HISTORIC AND DESIGN REVIEW COMMISSION

HDRC CASE NO: 2019-451

ADDRESS: 523 BURNET ST

TYPE OF WORK: Exterior alterations
APPLICATION RECEIVED: August 05, 2019
60-DAY REVIEW: October 04, 2019
CASE MANAGER: Edward Hall

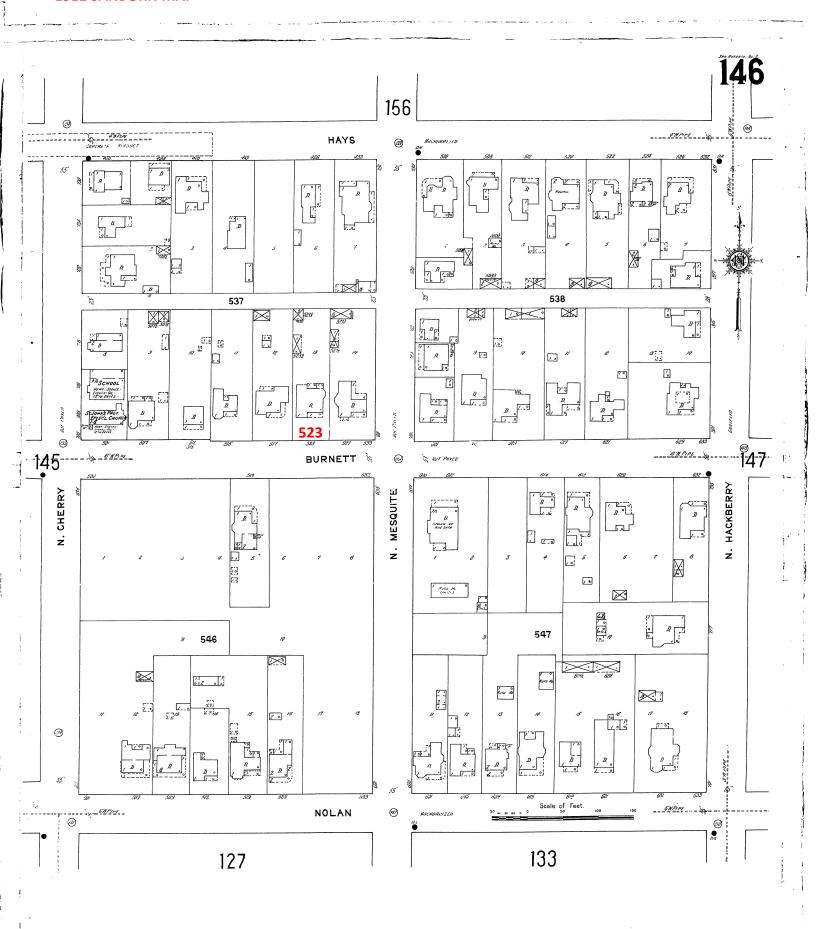
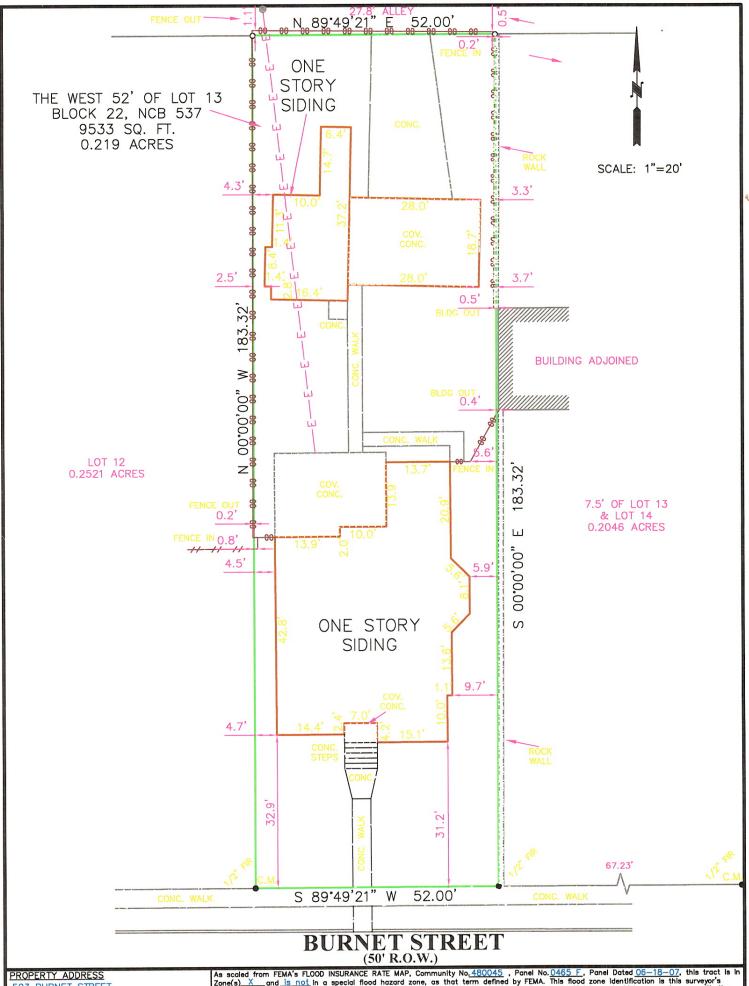
- d. PORCH RESOTRATION (Columns) The applicant has noted the installation of three square porch columns, one of which is to feature a pediment. Staff finds this to be inappropriate for the Folk Victorian style. Staff finds that the applicant should install porch columns to the immediate right of the porch and at the corner of the porch. If original columns are sourced, the half wall columns at the left and rear corner of the porch should also be installed. Replacement columns should feature a size six inches square with both capital and base trim and chamfered corners.

- e. PORCH RESTORATION (Railings) The applicant has proposed to install porch railings. While they may not have original existed, staff finds that railing may be appropriate in the proposed porch reconstruction; however, staff finds that the porch railings should be simple in design as to not appear original. The proposed railings should feature both a top and bottom rail. The bottom rail should feature a vertical orientation and should be installed approximately three to four inches above the porch decking. Both top and bottom rails should be constructed from 2"x4" members. The proposed railing should not feature an overall height of more than three (3) feet.

- g. PORCH FAÇADE (Fenestration) The applicant has not included windows in the proposed porch reconstruction. Staff finds that windows should be added to the front façade and should be installed to be consistent with the historic window depth found on the structure. Staff finds the front windows should be paired and spaced evenly between the right wall and front door. The windows should feature widths, head height and sill height that match that of those found historically on the structure. Regarding window materials, staff finds that a double-hung, one-over-one wood be used. Meeting rails must be no taller than 1.25" and stiles no wider than 2.25". White manufacturer's color is not allowed, and color selection must be presented to staff. There should be a minimum of two inches in depth between the front face of the window trim and the front face of the top window sash. This must be accomplished by recessing the window sufficiently within the opening or with the installation of additional window trim to add thickness. Window trim must feature traditional dimensions and architecturally appropriate sill detail. Window track components must be painted to match the window trim or concealed by a wood window screen set within the opening.

- ii. That the applicant install porch columns to the immediate right of the porch and at the corner of the porch. If original columns are sourced, the half wall columns at the left and rear corner of the porch should also be installed. Replacement columns should feature a size six inches square with both capital and base trim and chamfered corners. The proposed column with a pediment should be eliminated.

- iii. That the proposed railings feature both a top and bottom rail. The bottom rail should feature a vertical orientation and should be installed approximately three to four inches above the porch decking. Both top and bottom rails should be constructed from 2"x4" members. The proposed railing should not feature an overall height of more than three (3) feet.

- iv. That the applicant install porch fascia and soffit materials that match those found historically on the structure.
- v. That windows be added to the front façade and should be installed to be consistent with the historic window depth found on the structure. Staff recommends that the front windows be paired and spaced evenly between the right

wall and front door. The windows should feature widths, head height and sill height that match that of those found historically on the structure. Regarding window materials, staff finds that a double-hung, one-over-one wood be used. Meeting rails must be no taller than 1.25" and stiles no wider than 2.25". White manufacturer's color is not allowed, and color selection must be presented to staff. There should be a minimum of two inches in depth between the front face of the window trim and the front face of the top window sash. This must be accomplished by recessing the window sufficiently within the opening or with the installation of additional window trim to add thickness. Window trim must feature traditional dimensions and architecturally appropriate sill detail. Window track components must be painted to match the window trim or concealed by a wood window screen set within the opening.
